# Service Bulletin No. 433B

<i>MODEL</i>	<b>J4500 Series</b>	<i>TYPE</i>	<b>Field Change Program</b>	<i>SECTION/GROUP</i>	<b>3-Body</b>	<i>DATE</i>	
<i>SUBJECT</i>	<b>WINDOW MOUNTING HARDWARE</b>						
<i>CONDITIONS</i>

**THIS BULLETIN SUPERCEDES SERVICE BULLETIN 433 IN ITS ENTIRETY.**

**Figure 1. Non-egress window bracket rework locations only.**

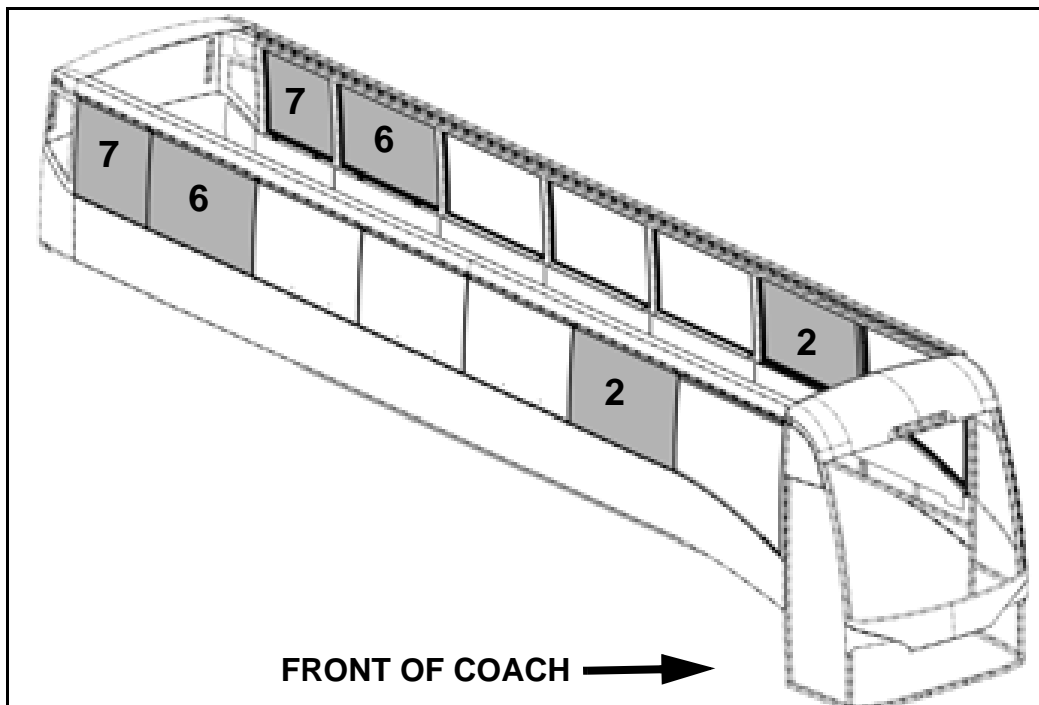
*The outlined procedure steps in this bulletin are applicable only to the #2, #6 and #7 non-egress windows on both the curbside and roadside of the coach ( refer to Figure 1 for designated locations ).*

*If the coach is equipped with a wheelchair lift, the curbside #7 window brackets do not require rework.*

**Figure 4.**

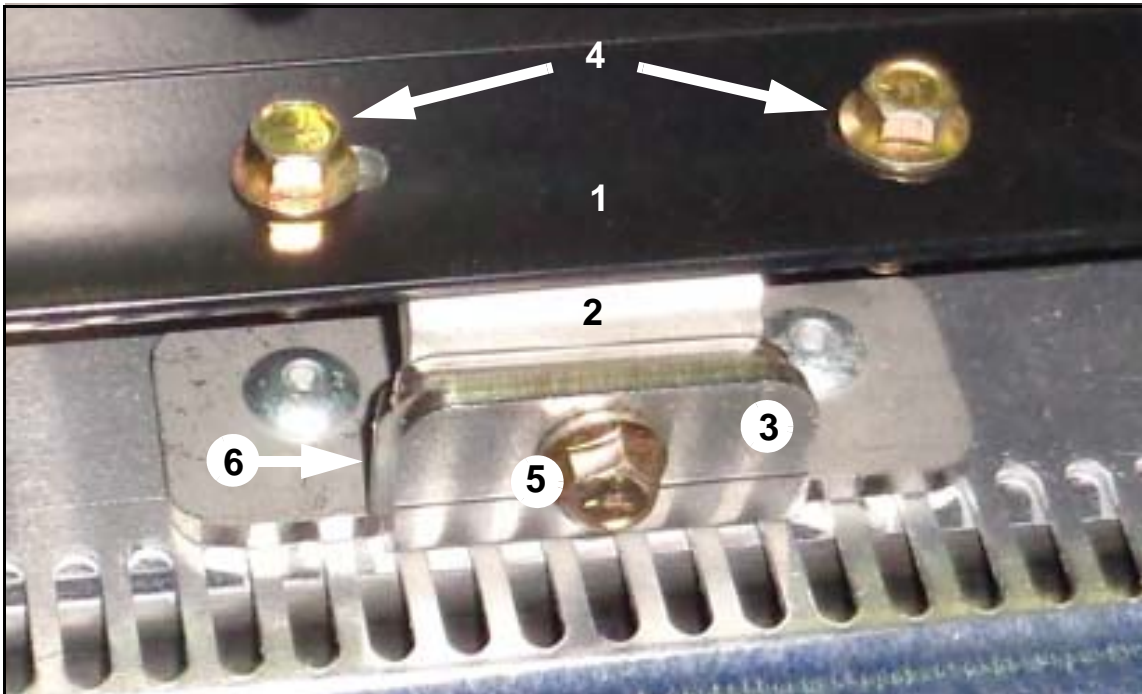
6. Locate one of two sets of mounting hardware ( Items 4 and 5 / Figure 4 ) securing the window to the upper and lower mounting brackets.

**If a horizontal mounting capscrew ( Item 5 / Figure 4 ) is missing, a new capscrew and eight ( 8 ) shims will need to be ordered for the bracket rework.**

- c. **Adjust the alignment of the rework window so that the two ( 2 ) adjacent window edge profiles are flush against the straight edge. Hold in position and add the necessary shims ( 0 to 4 shims ) to fill the gap between the lower mounting bracket and horizontal capscrew ( Items 3 and 5 in Figure 4 ).**

***Remove, add Loctite and re-install one ( 1 ) vertical bolt ( Item 4 / Figure 4 ) at a time to ensure exterior window symmetrical alignment.***

8. Remove one ( 1 ) vertical bolt ( Item 4 / Figure 4 ). Apply blue Loctite 243 to the threads and re-install. Position a wrench on the nut and torque the bolt to 8-10 ft-lbs.
9. Remove the remaining vertical bolt. Apply blue Loctite 243 to the threads and re-install. Position a wrench on the nut and torque the bolt to 8-10 ft-lbs.

***If installation contains shims, ensure that the shims are oriented completely vertical with no gaps therein.***

***If so equipped, all existing production shims must be re-installed to avoid window frame stress damage.***

10. Remove the horizontal bolt and shims ( if applicable ). Apply blue Loctite 243 to the threads. Orient the shims on the bolt and re-install. Torque the bolt to 8-10 ft-lbs.
11. Repeat Steps 6 to 10 to the other set of mounting hardware on the window.

**Figure 5.**

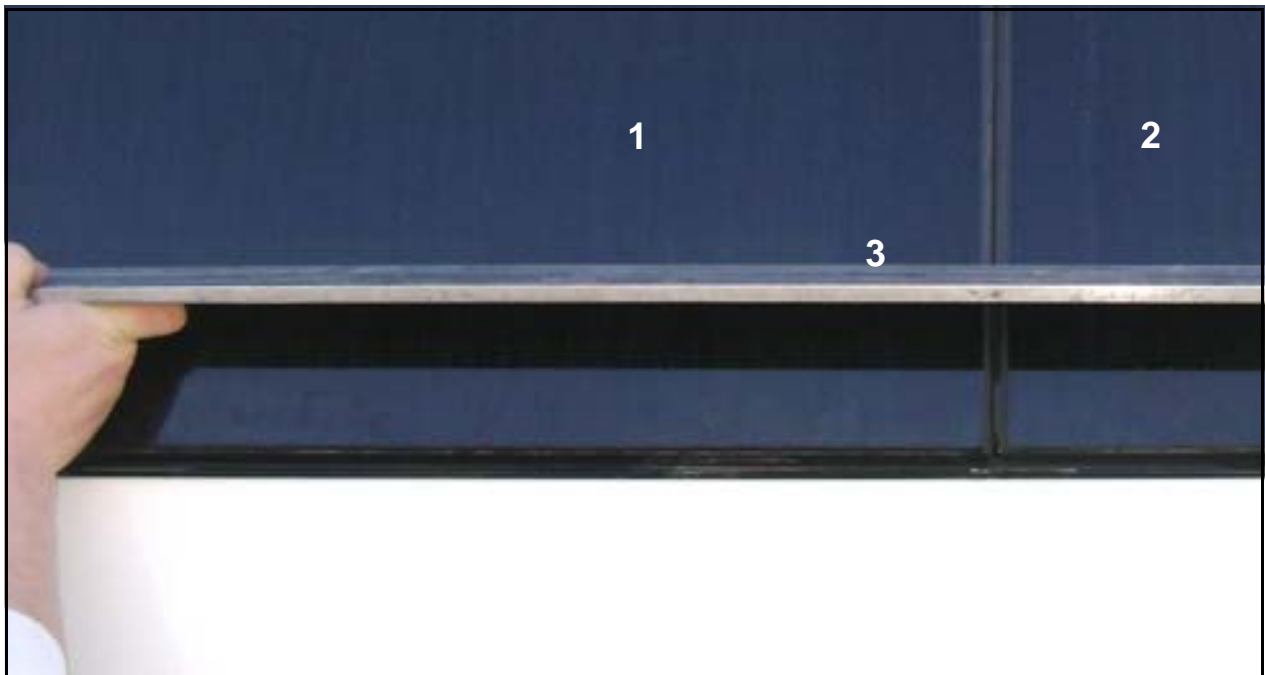
- a. **In front of the rework window, position one ( 1 ) person on a ladder outside the coach and another in the coach cabin,**
- b. **Outside the coach, position a cloth-covered straight edge across the rework window and the next adjacent window ( refer to Figure 5 ),**
